Wizards Workshop

January 16, 1981
Issue 11-1

TABLE OF CONTENTS

520A DIFFGAIN
Display of
149A Linearity Ramp

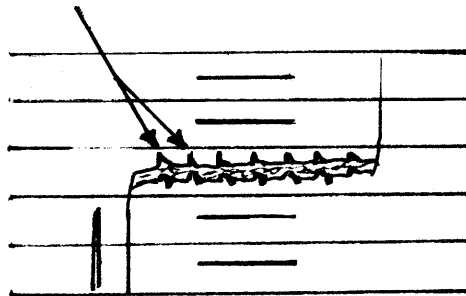
When observing a 149A's Linearity Ramp (Full Field Signal) with a vectorscope and checking for differential gain, a signal anomaly, seen as seven transitions, appears on the displayed waveform (see illustration). This is caused by an circuit board run carrying current to the color bar generating circuitry passing close to linearity modulation amplitude circuitry. If a customer requests that this be corrected:

- 1) Lift cathode of CR3411 from ECB
- 2) Lift cathode of CR3413 from ECB
- 3) Lift diode end of R3311 from ECB
- 4) Lift diode end of R3337 from ECB
- 5) Lift emitter leg of Q3420 from socket
- 6) Connect the free ends of these parts together "teepee" style with short lengths of wire

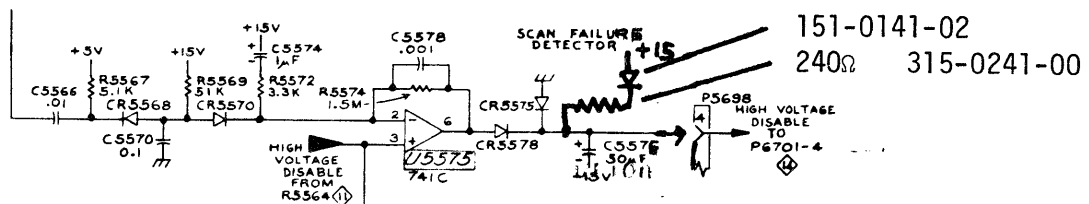
A condition exists under which the 670 monitor appears to misconverge. Should a momentary power loss occur, sufficient energy remains in some sections of the high voltage and deflection circuits to cause abnormal beam deflection, and thereby a secondary emission phenomenon when power is restored in a short enough time span. This appears as misconvergence of the CRT, and tends to give the picture a green tint.

Any change in beam current, i.e. contrast or brightness, will cure the immediate problem, however, if a customer desires a more concrete solution, two parts can be added to the scan fail detection circuitry as follows:

Connect one end of a 240 ohm resistor (P/N 315-0241-00) to CR5575 or CR5578 at the cathode end. Connect a diode (152-0141-02) between the free end of the 240 ohm resistor and +15 volts, cathode end to the resistor (see illustration).

Fig. 8-10. A4- Digital Voltmeter circuit board assembly.

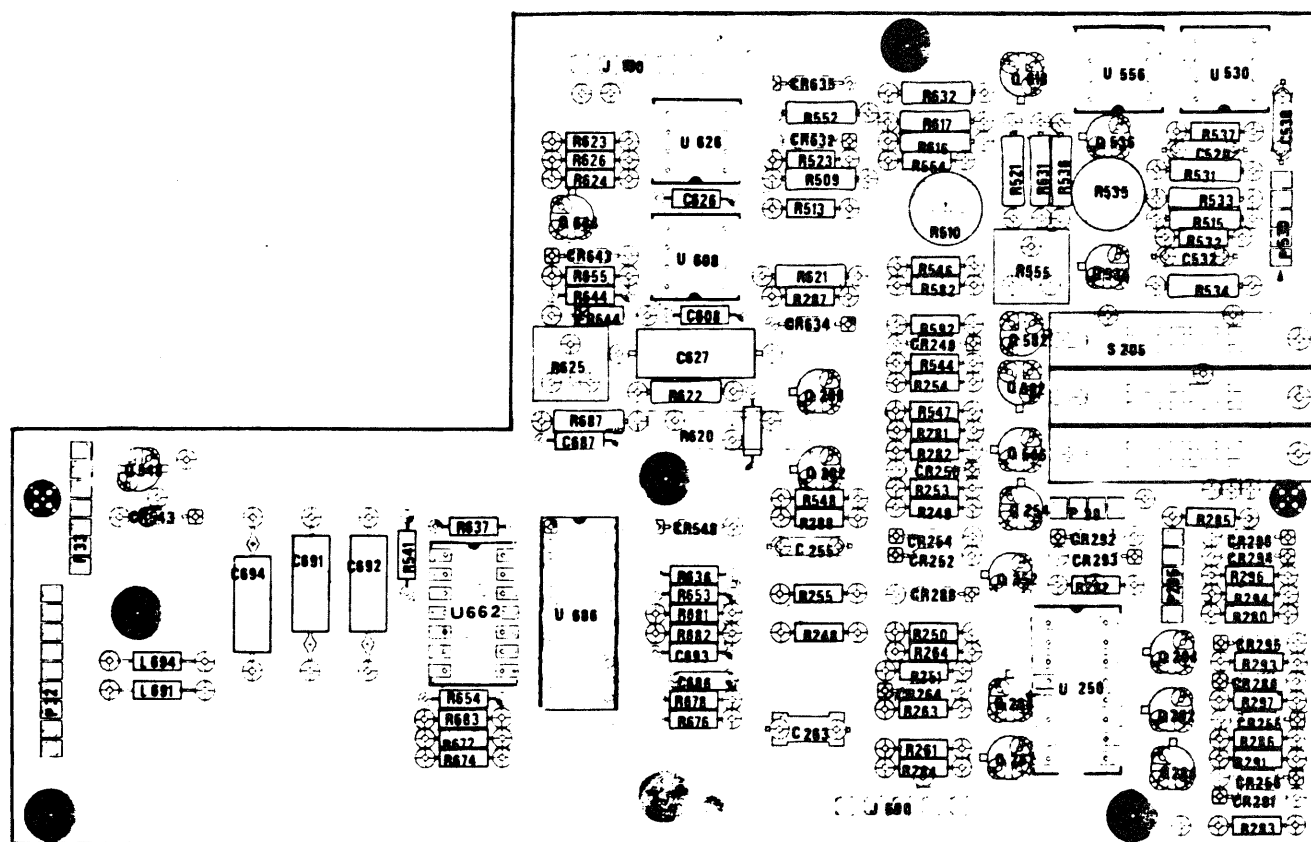
REPLACE: Fig. 8-10 with the illustration shown below.

DIAGRAM 6 DIGITAL VOLTMETER (DVM)

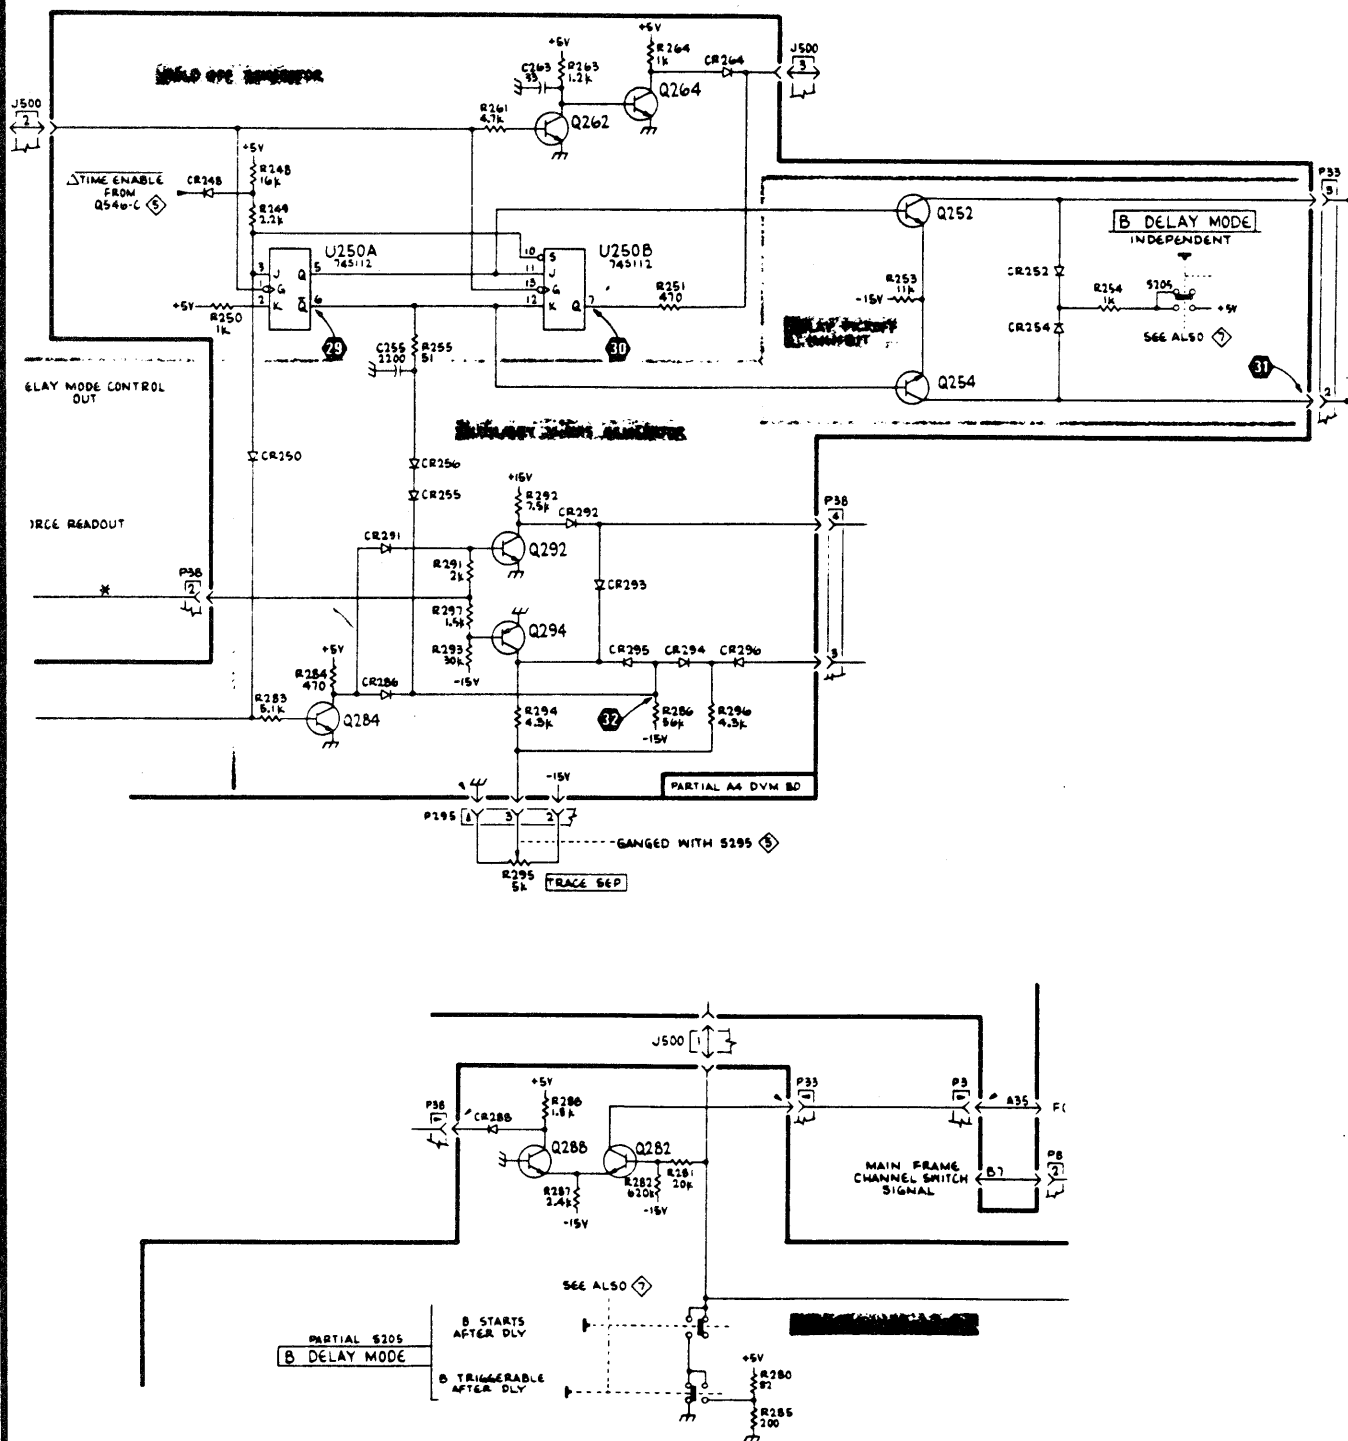
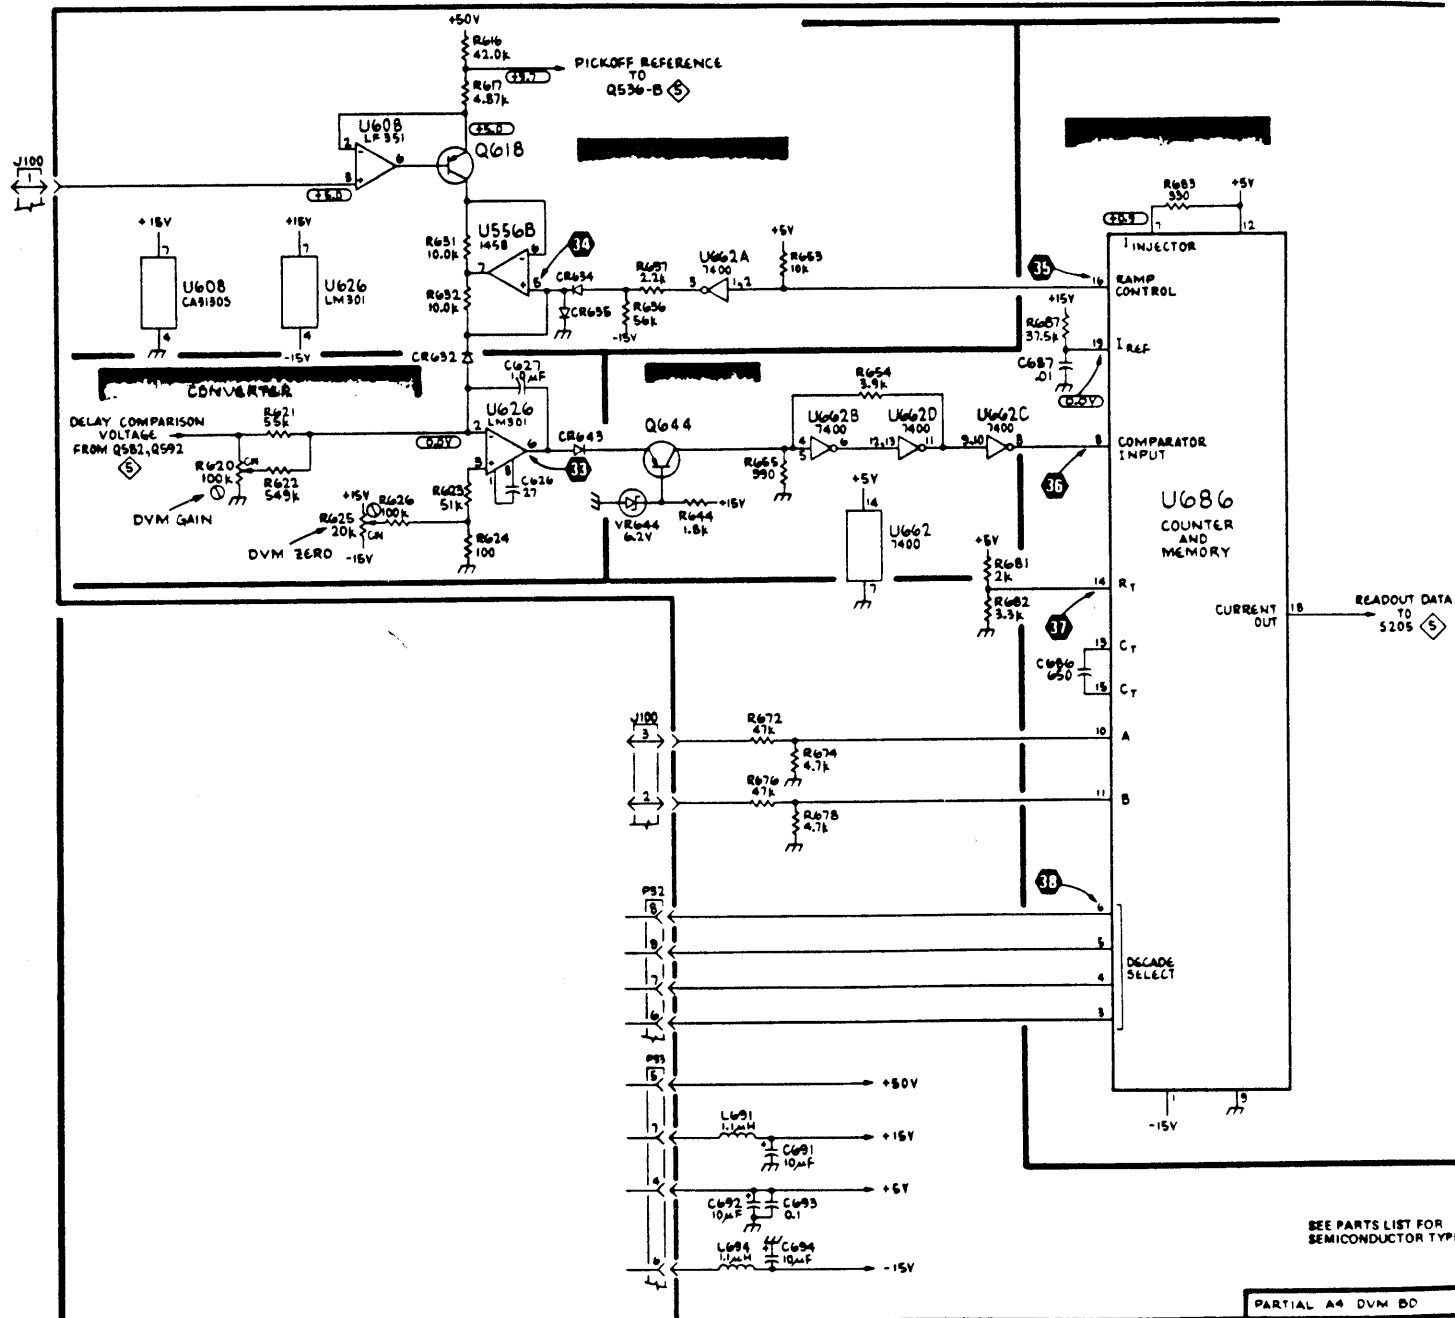
REPLACE: A4 Digital Voltmeter schematics with the following:
